Re: Second Submission Review – Town Center at Aurora Phase 2 – Site Plan Amdt and Plat
Application Number: **DA-1105-17**
Case Numbers: **1985-6028-27**

Second Submission Review

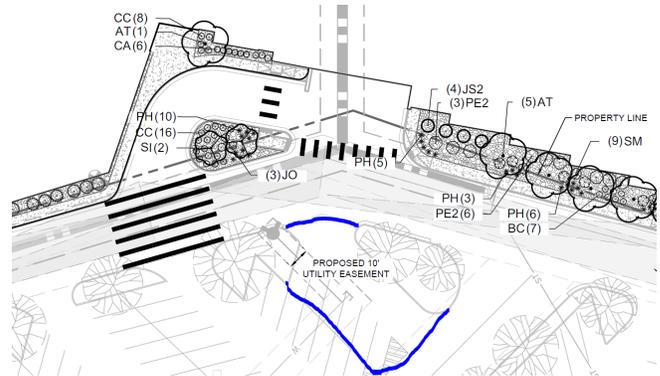
- 3A. Please provide a letter listing all proposed adjustments (which includes landscaping adjustments) and justifications. Furthermore, adjustments should be listed on the cover sheet of the Site Plan set.
- 3B. Pedestrian Connectivity. There are additional opportunities to reduce pedestrian/vehicle conflicts.
- 3C. The sidewalk along Sable Boulevard should match the width of the sidewalk adjacent to the Metro Center. Since there is a lot of pedestrian activity along this corridor wider sidewalks are necessary.
- 3D. The sidewalk along the driveway to the mall (across Sable Blvd from Centrepoint Drive) shall be at least 12’ feet wide and contain street tree cutouts. Since the landscape buffer between the building and the sidewalk is small, the street trees will provide for additional buffering as well as a visual break between pedestrian and vehicular circulation.
